Mask Set Errata for Mask 1L38H

This mask set errata applies to the mask 1L38H for these products:

- MC68HC908EY16
- MC68HC908EY8

Figure 1. Maximum Time for Other Execution

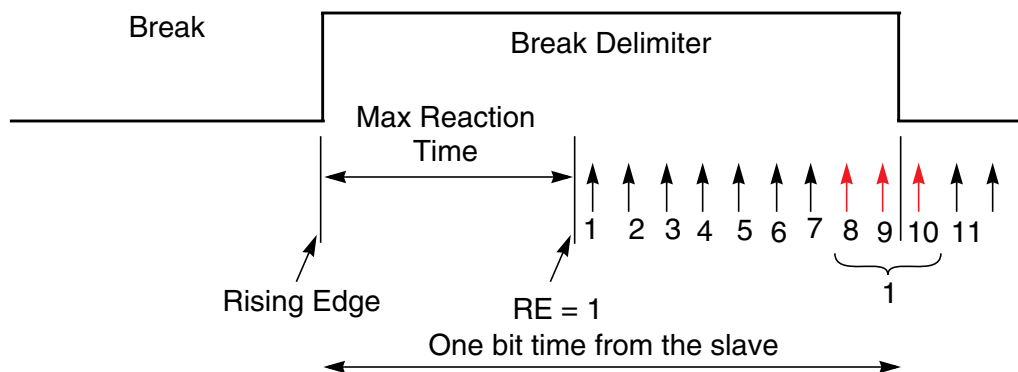
The time between when the rising edge actually appears on the receive pin and when the receiver is switched back on is finite and is governed by the timing of the falling edge of the delimiter. The receiver must be switched back on no later than 9/16th of a bit time before the end of the delimiter. See [Figure 1](#).

From Figure 1, we also see that the “Maximum Reaction Time” is 7/16th slave bit-time.

The Maximum Reaction Time for this example system is $7/16 \times (44.5 \mu\text{s}) = 19.47 \mu\text{s}$.

From the instant the rising edge appears on the receive pin (detected via the arbiter AFIN bit or a timer interrupt), the software has to switch the receiver OFF and back ON within 19.47 μ s.

Because ground shift in the physical layer might also affect the timing of the falling edge of the START bit of the 0x55 synch byte (i.e., the end of the delimiter), best design practices suggest that the switching of the receiver should be done as quickly as possible after the rising edge is detected. The maximum reaction time calculated above should be treated as a guideline only.
